UNITED STATES PATENT AND TRADEMARK OFFICE

09/957,451

| Office Action Summary | Application No. 09/957,451 | Applicant(s) SCHURR ET AL. | |

DETAILED ACTION

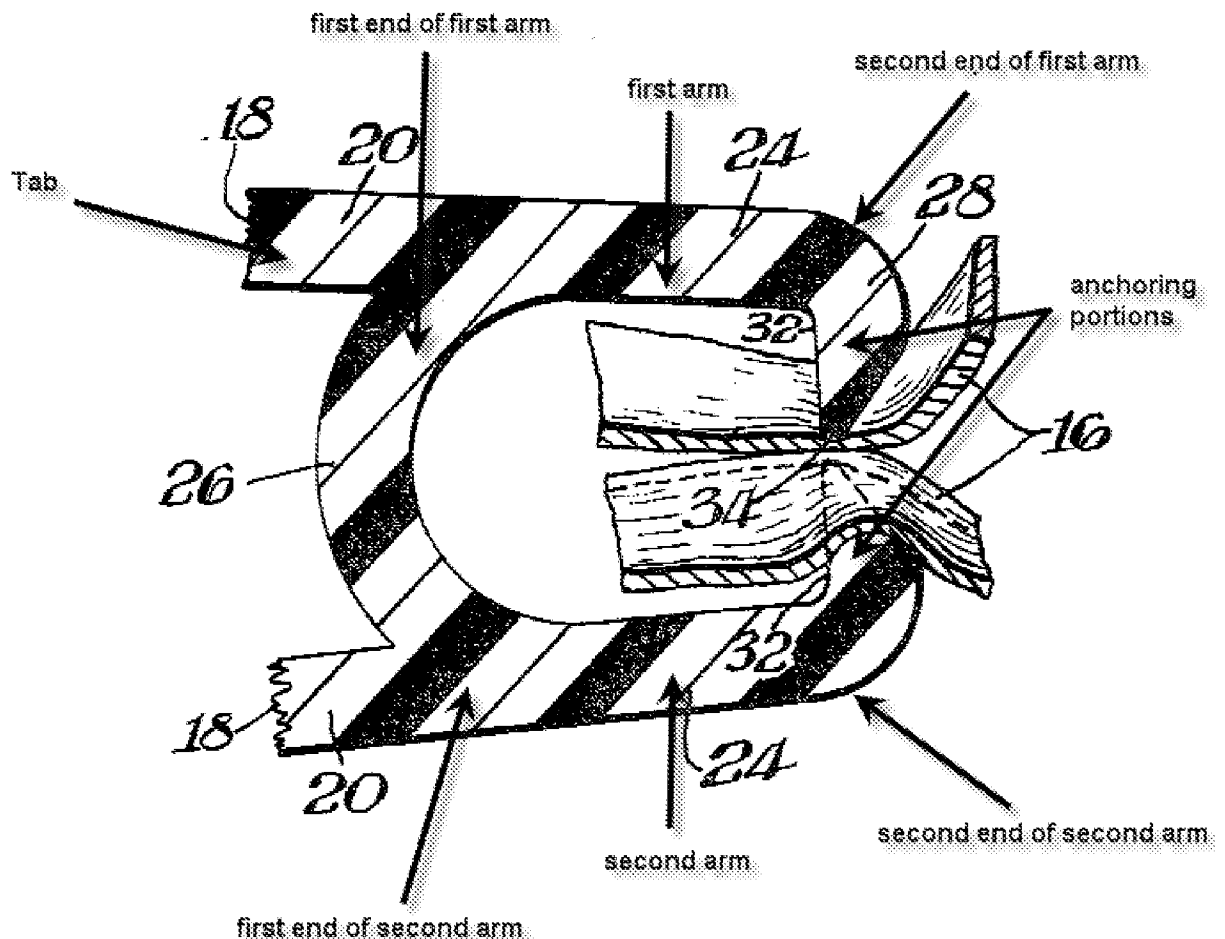
(claims 1, 120, 135 and 148) Le Roy discloses a clip that is fully capable of securing a fold of tissue for treating GERD, the clip comprising:

a first arm (see attached figure below);

a second arm disposed substantially opposite from each other (see figure below),

wherein the first and second arms have a first end fixedly connected to each other to define an opening that is capable of receiving a fold of tissue (see figure below)

wherein the first and second arms is capable of extending substantially in the same direction as the fold of tissue (see figure below),

wherein the opening allows tissue to extend beyond a second end of the first and second arm (see figure below),

wherein the second ends of the first and second arms are capable of maintaining a non-contacting relationship when in a deployed stated (a tissue is located between the second ends of the first and second arm which would prevent the first and second arms from contacting),

wherein the second arm **18** includes integral anchoring portions **50**, which are projections that are capable of maintaining a non-contacting relationship with the other of the first and second arms during a deployed state,

(claims 5, 131, 144 and 154) The clip includes a gripping tab, as shown in the figure above and in Figs. 1 and 3.

(claims 124, 137, 138, 150-152, 172, 174, 176 and 178) The anchoring portion is viewed as a reverse angle barb projection. As shown in the figure above, the anchoring portion is barb-like with an angle that can be viewed as reversed.

(claims 126, 127, 140, 180 and 181) The anchoring portion includes two projections that are located directly opposite to one another along the first and second arms (see figure above).
